PROPOSED CORRECTIONS TO THE GTR ON PEDESTRIAN PROTECTION

Document ECE/TRANS/WP.29/2007/94

Figure 12, replace by:

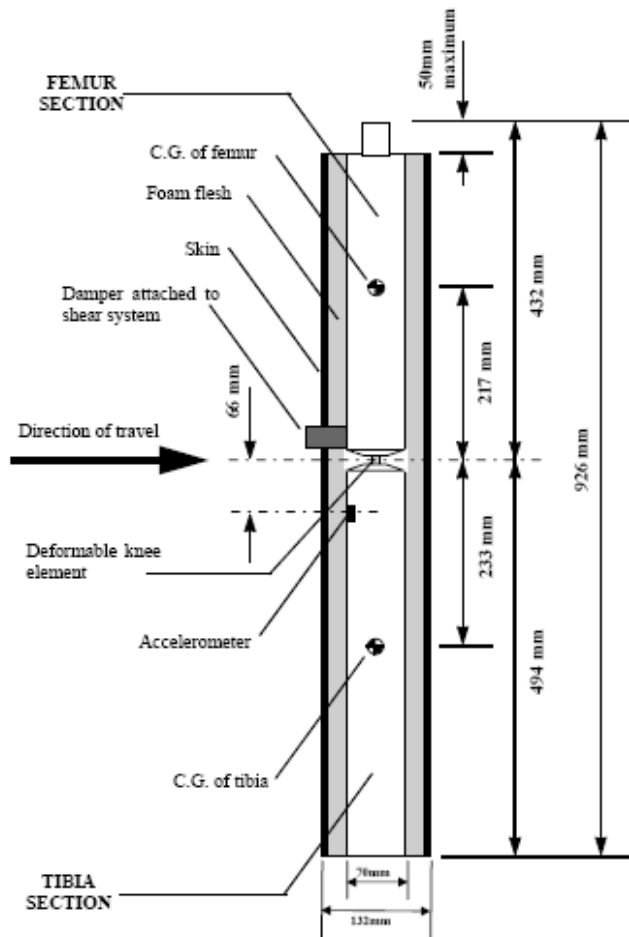
Figure 12: The existing figure 12 is not complete, since it does not show the overall diameter of 132 mm.

“... test mass of 13.4 ± 0.2 kg (see Figure 12). **Dimensions of the various parts are detailed in Figure 12.**
